**MEETING AGENDA
SESSION OF THE PLANNING ADVISORY BOARD
CITY OF KISSIMMEE
CITY HALL, COMMISSION CHAMBERS
101 CHURCH STREET, KISSIMMEE, FLORIDA 34741-5054
WEDNESDAY, JUNE 21, 2023 AT 6:00 PM**

PERMIT NUMBER: ZMA-22-0007

Public Hearing - Conditional Use with Site Specific Redevelopment Plan request to convert a residential property to office use - 1012 Mabbette Office Conversion, CU-22-0023

DATE: 4/26/2023
PROJECT: 1012 MABBETTE ST
SITE PLAN (DRC) NUMBER: CU-22-0023
REVIEW NUMBER: 2

DRAWN	VERN
CHECKED	
DATE	
SCALE	AS SHOWN
JOB NO.	
SHEET	
	A-1
OF	
SHEETS

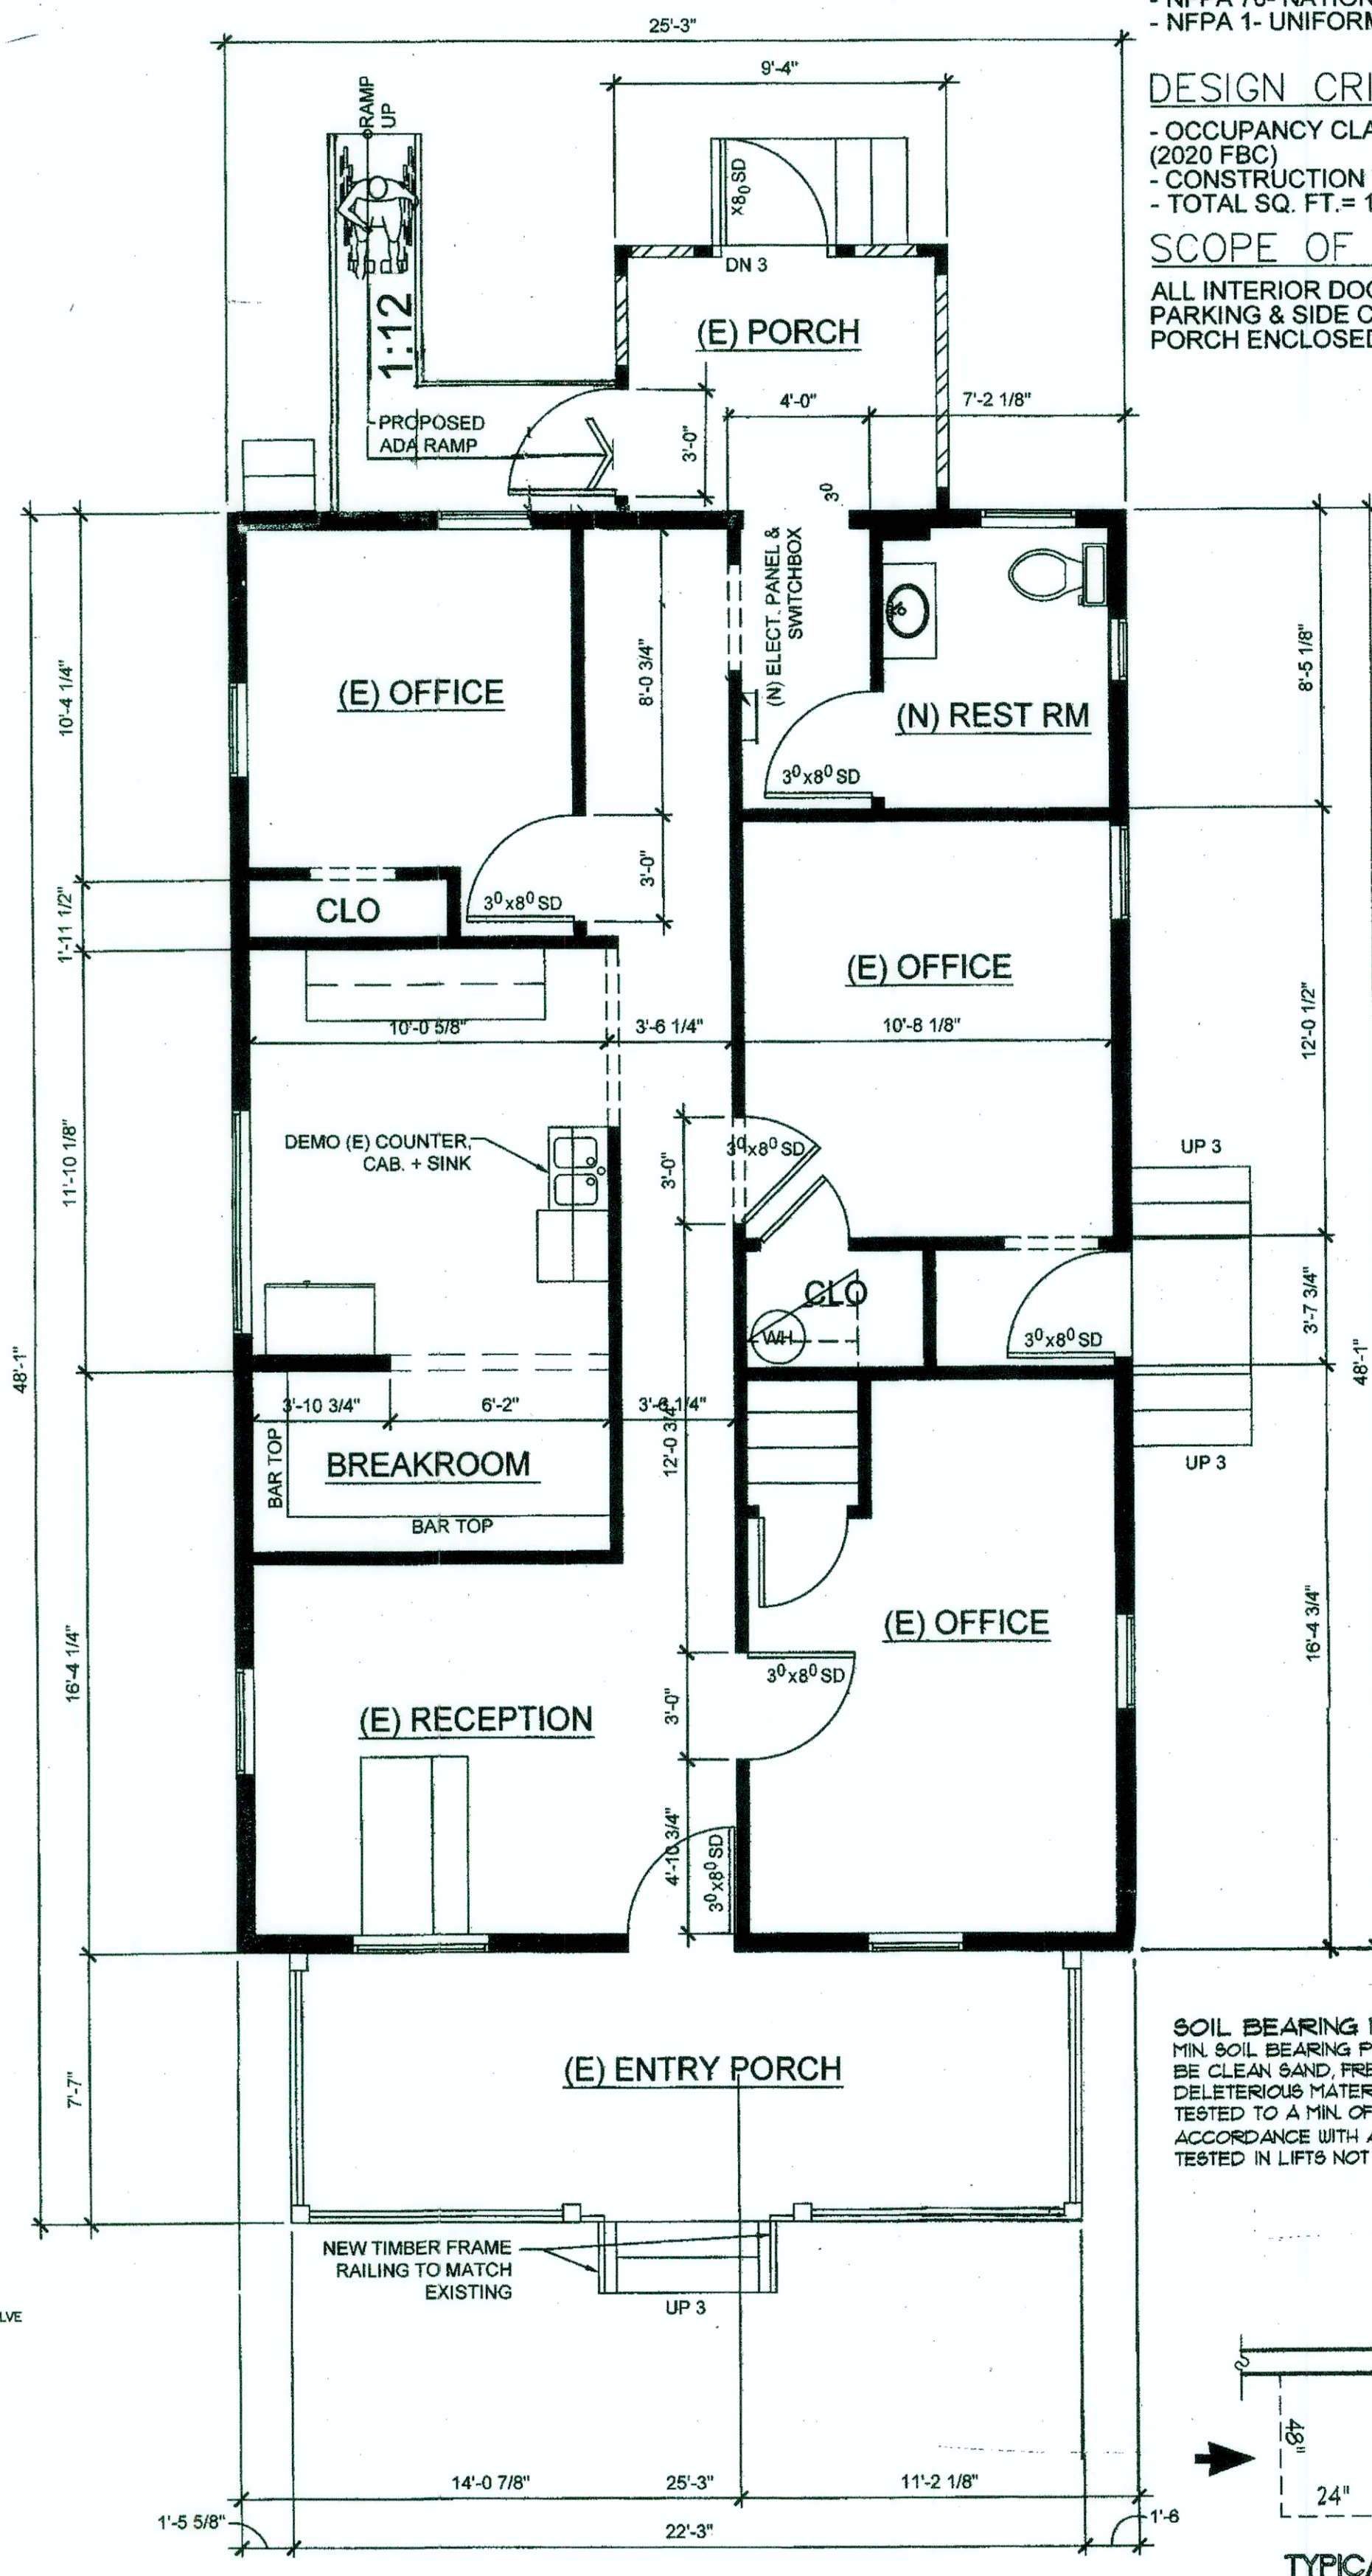
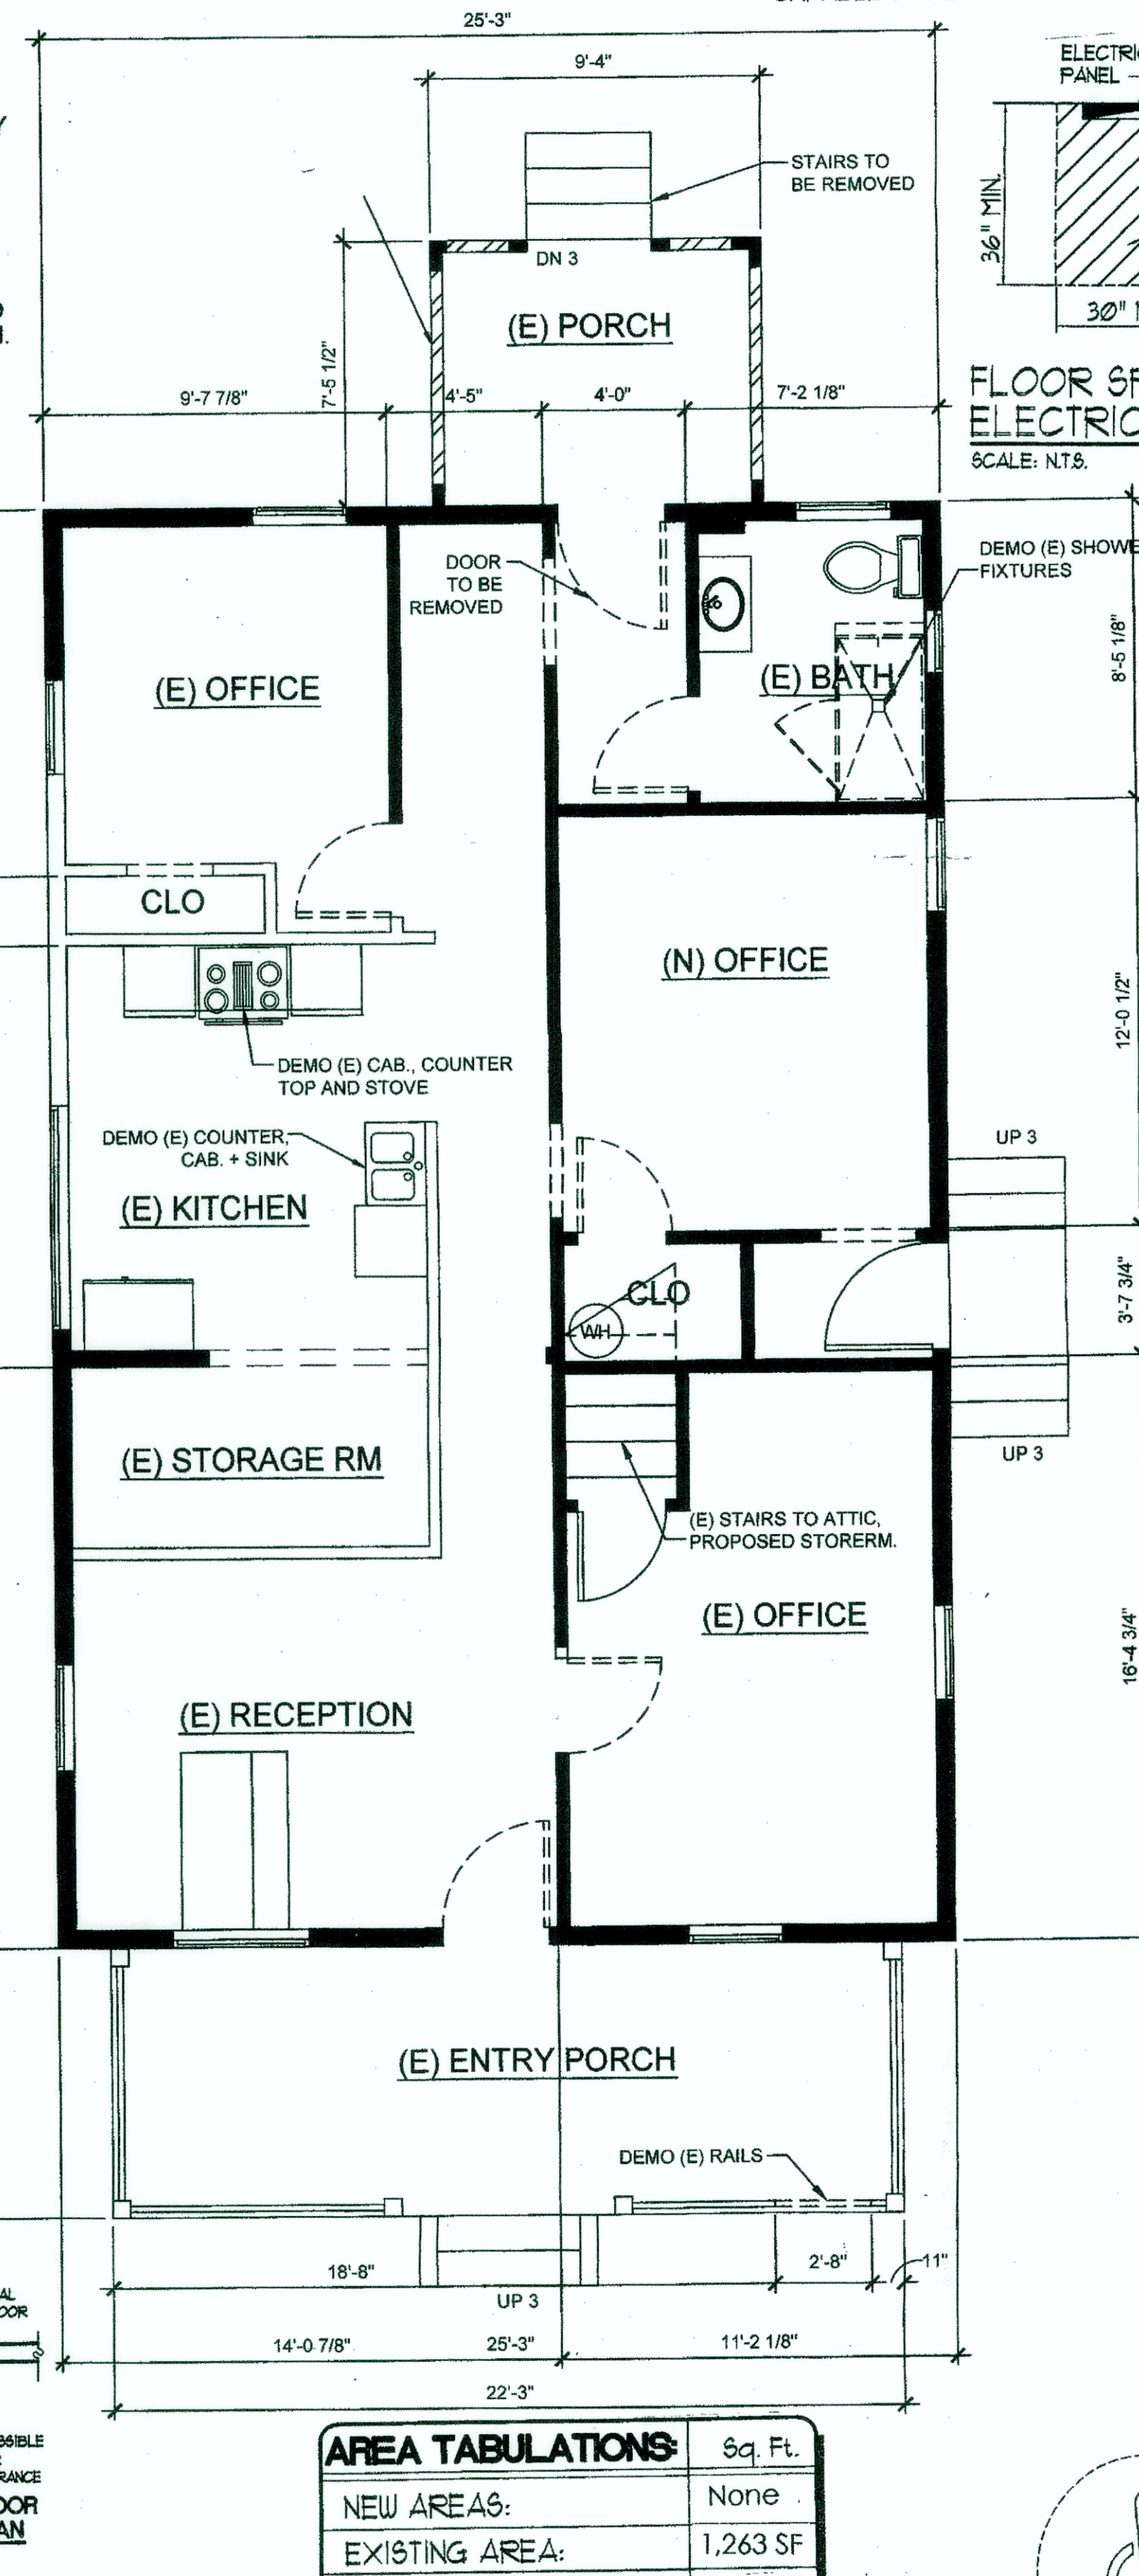
- c)
2. There are trees depicted to remain. A tree survey should be provided to identify the trees species and tree size of any trees to remain. Landscaping plans must also include tree barricade detail that includes construction mesh fence which is not permitted. Refer to Tree Protection Barricade Detail below and replace the tree protection diagram on Sheet L-000. 14-8-6C

- d. Each section shall be clearly flagged with yellow plastic tapes or other markers.
 3. Provide a note on the plans that all mechanical equipment located outdoors, such as heating, ventilation, air conditioning, refrigeration systems, and KUA transformers, shall be visually screened from adjacent rights-of-way. Provide the location of all such mechanical equipment, and indicate the location and types of screening to be used. 14-2-65 (K)

4. Provide an irrigation system plan for all pervious areas, which indicate the location, type, connections, meter, rain sensor device, and backflow preventer. Said plans shall be provided in conjunction with preliminary site development plans and approved prior to final site development plan approval. 14-2-91(B)(12)

- Property boundary monumentation
 - Vertical datum and benchmark
- Provide lowest finished floor elevation information on the construction drawings.
- All 90-degree parking spaces shall have 24 FT of backing distance.

- Only the one (1) two-way access drive on the west side of the building will be permitted.
- The driveway entranceway shall provide unobstructed stacking distance(s) of 7 FT in accordance with LDC §14-7-23(D).
